Doonside Station Upgrade

Determination Report

Figure 3 Revised key features of the Proposed Activity (indicative only, subject to detailed design)

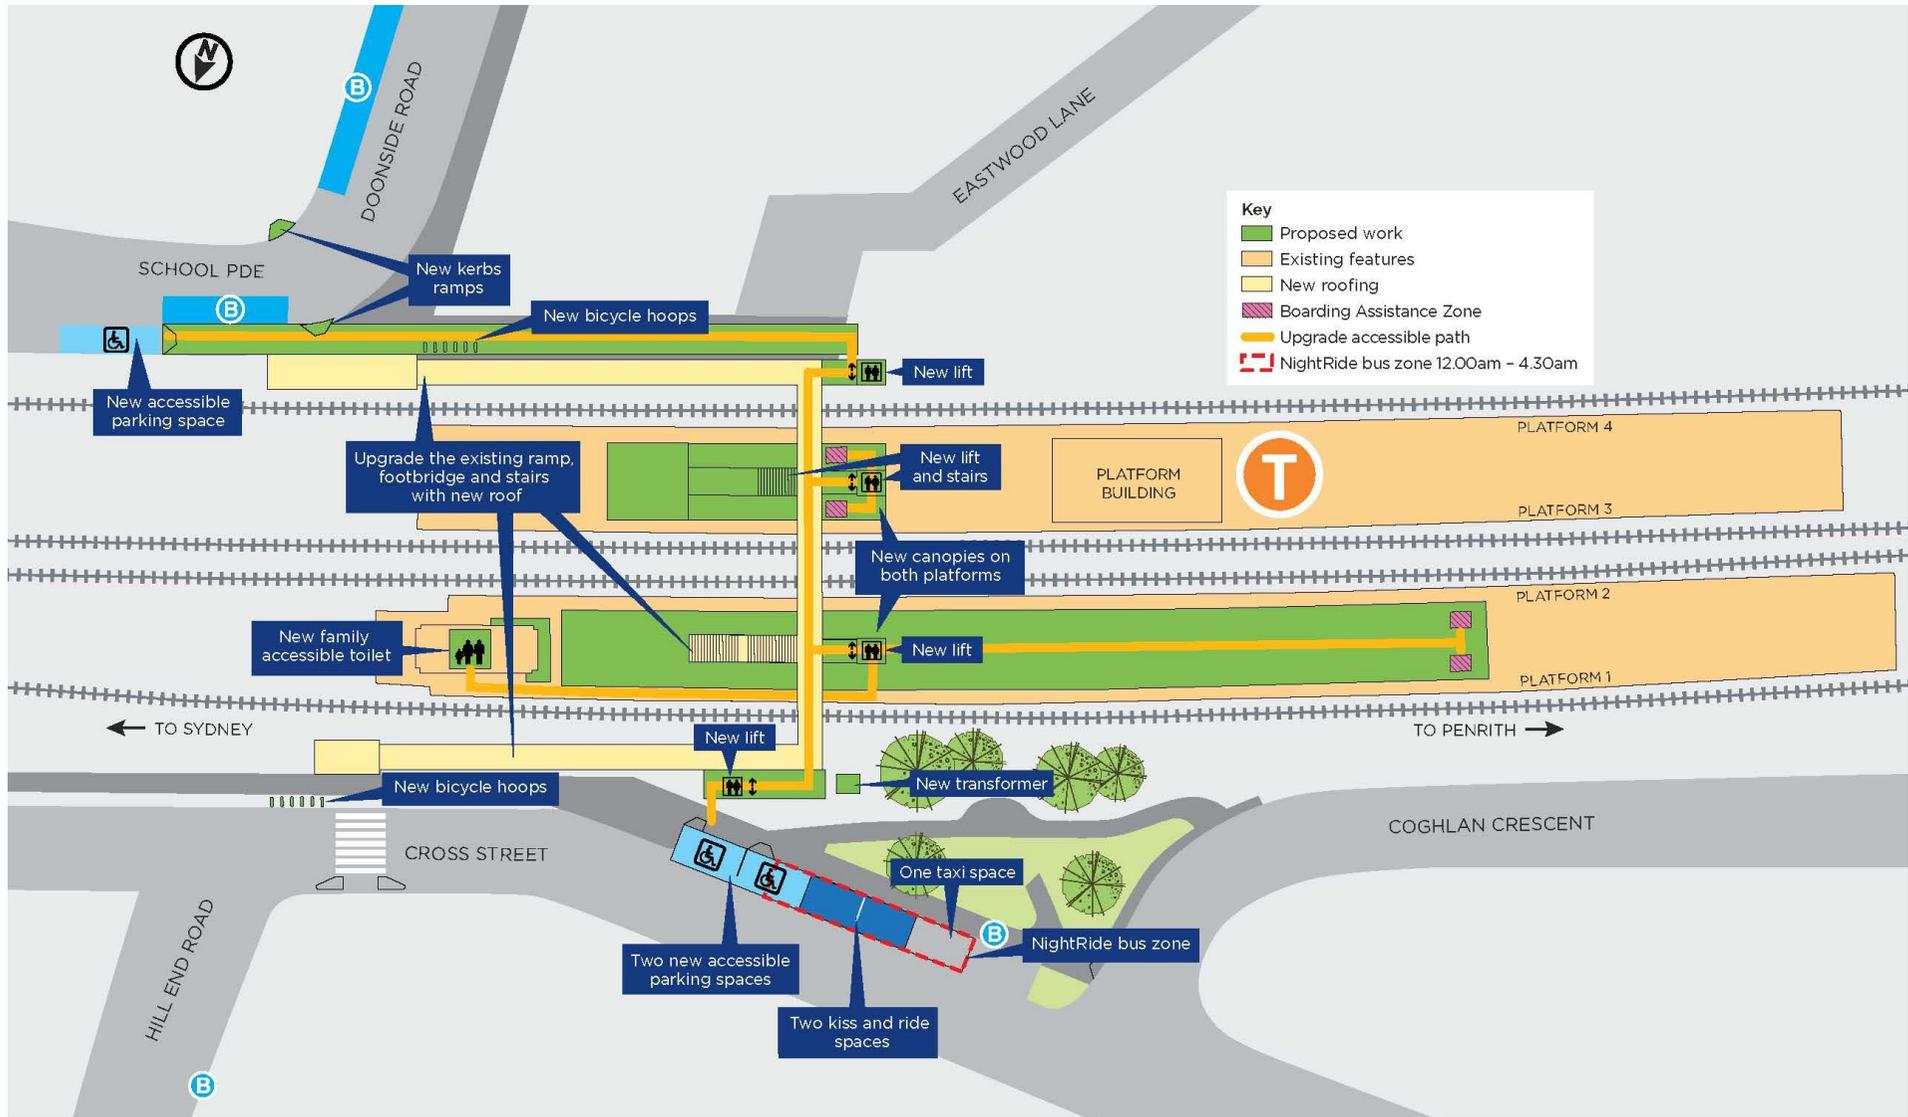
Aspect of the Proposed Activity	Design change	Discussion of impacts
School Parade access	A kerb ramp would be installed on both sides of the road at the corner where Doonside Road transitions into School Parade, to facilitate greater access between the station and the bus stop adjacent to Doonside Public School.	The introduction of a kerb ramp would not result in any adverse environmental impacts from what has already been assessed in the REF. The kerb ramps provide an improvement to the design by facilitating improved access between the station and the bus stop adjacent to Doonside Primary School.
Accessible car parking space on the southern side of Doonside Station	<p>The proposed location of the accessible car parking space on the southern side of Doonside Station has been moved to School Parade in front of the existing public parking bays. The introduction of the accessible car parking space at this location would result in the removal of up to four parking spaces.</p> <p>This change would be implemented as it would:</p> <ul style="list-style-type: none"> locate the accessible parking space with existing car parking spaces provide clearer sightlines to the station provide reduced travel distances to the station. 	<p>The relocation of the accessible car parking space would retain the single 30-minute parking spaces on the western side of Doonside Road. However, the relocation would result in the permanent loss of up to four untimed parking spaces. This is anticipated to have a minor impact given the alternative time-restricted and unrestricted parking available on nearby streets.</p> <p>The relocation of this parking space would require the existing stormwater drainage pit to be adjusted or relocated which may cause sediment to enter the stormwater system. To manage risks to water quality, an Erosion and Sediment Control Plan would be prepared and implemented for the Proposal. This would include specific controls to protect the stormwater network around Doonside Station.</p>

Aspect of the Proposed Activity	Design change	Discussion of impacts
Location of night ride bus stop on the northern side of Doonside Station to change	<p>The location of the existing night ride bus stop would be maintained to share the space with the existing taxi parking bay, the two new kiss and ride bays and half of one of the new accessible car parking spaces. This change would only occur between 12:00am and 4:30am when the night ride bus is operational. During that time, only one accessible parking space would be available. Appropriate sign posting would be placed to indicate the new time and parking restrictions.</p> <p>This change is proposed as the location of the bus stop in the original design was too close to the corner of Coghlan Crescent and would have potentially blocked the view of cars attempting to leave Coghlan Crescent onto Cross Street. Further, the bus would have also been required to stop on the road, preventing traffic from being able to pass it safely. The modified design prevents the safety and traffic issues that may have arisen from the original design.</p>	<p>The night ride bus stop operates between 12:00am and 4:30am when trains are not operating from Doonside Station. During those hours demand for accessible parking or kiss and ride bays for Doonside Station would be low. This change is expected to have a negligible overall impact.</p>
